NRC Clarification Questions for CH2M Hill Contractors Regarding the West Valley Demonstration Project Main Plant Process Building Demolition Modeling

Documents Reviewed:

- **WVDP-605:** Estimated Radiological Air Emission During Open-Air Demolition, Main Plant Process Building
- **WVDP-606:** West Valley Demonstration Project Main Plant Process Building, Main Plant Process Building Radionuclide Inventory for 40 CFR 61 Subpart H
- **WVDP-607:** Air Dispersion Modeling for Open-Air Demolition, Main Plant Process Building

Table 1 Output from AERMOD Model Files Provided by DOE

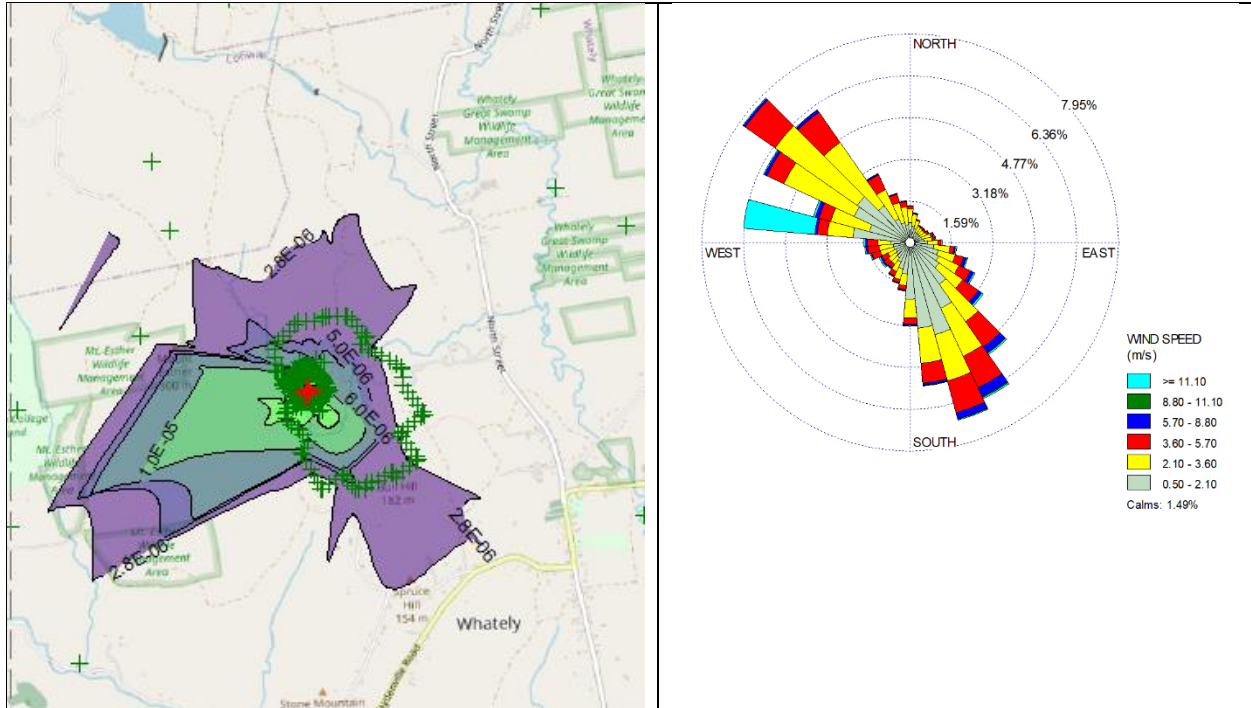
10. **After reviewing and running the AERMOD input files provided by DOE, some unexpected behavior is noted in the output/results.** Please see figure below generated by AERMOD View (Using Lakes Environmental v. 10.0.1). The NRC staff also has the following questions on model parameters and consideration of uncertainty:

- Explain the stray concentrations in the NW (insufficient offsite receptor locations; glitches with contour algorithm at low concentrations).
- Explain the bias in the results to the W/SW (what meteorological conditions are causing these results), or provide the star or other format meteorological data by stability class.
